CITY OF RAMSEY LAND USE APPLICATION
TECHNICAL REVIEW FILE

DATE	APRIL 17, 2018	PROJECT ADDRESS	CORNER OF CENTER STREET NW AND 146 TH AVENUE NW
PROJECT. TITLE	FINAL PLAT & REVISED SITE PLAN REVIEW		
ESCROW #	116093		
DEPARTMENT:	Community Development: Planning Division (Zoning Code)		
TECHNICAL REVIEWER:	Name: Eric Maass, Consultant Planner Phone: 763-576-4306 Email: EMaass@wsbeng.com

Final Plat Review

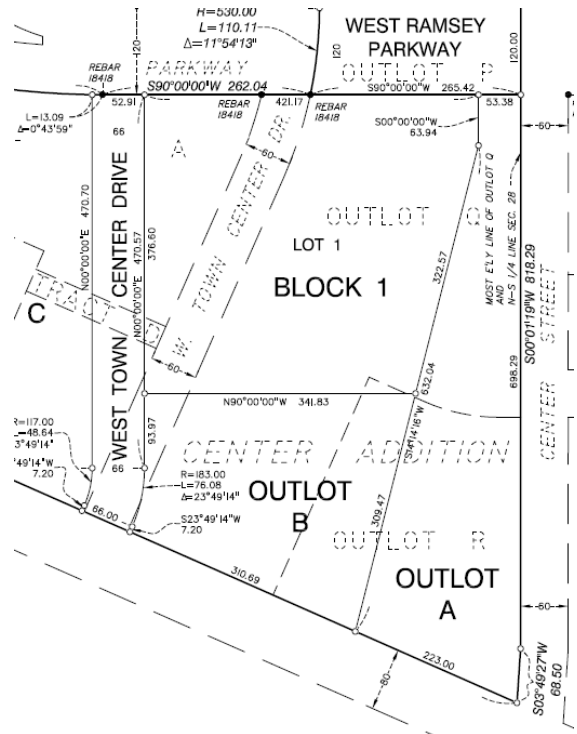
Lot Dimensions. There is no minimum lot size in the COR 1 Mixed Use Core subdistrict. The minimum lot width is 20 feet, measured at the building setback line, and the minimum lot depth is 80 feet. The proposed lot (Lot 1 Block 1) and two outlots (Outlot A and Outlot B) are depicted in the image to the right.
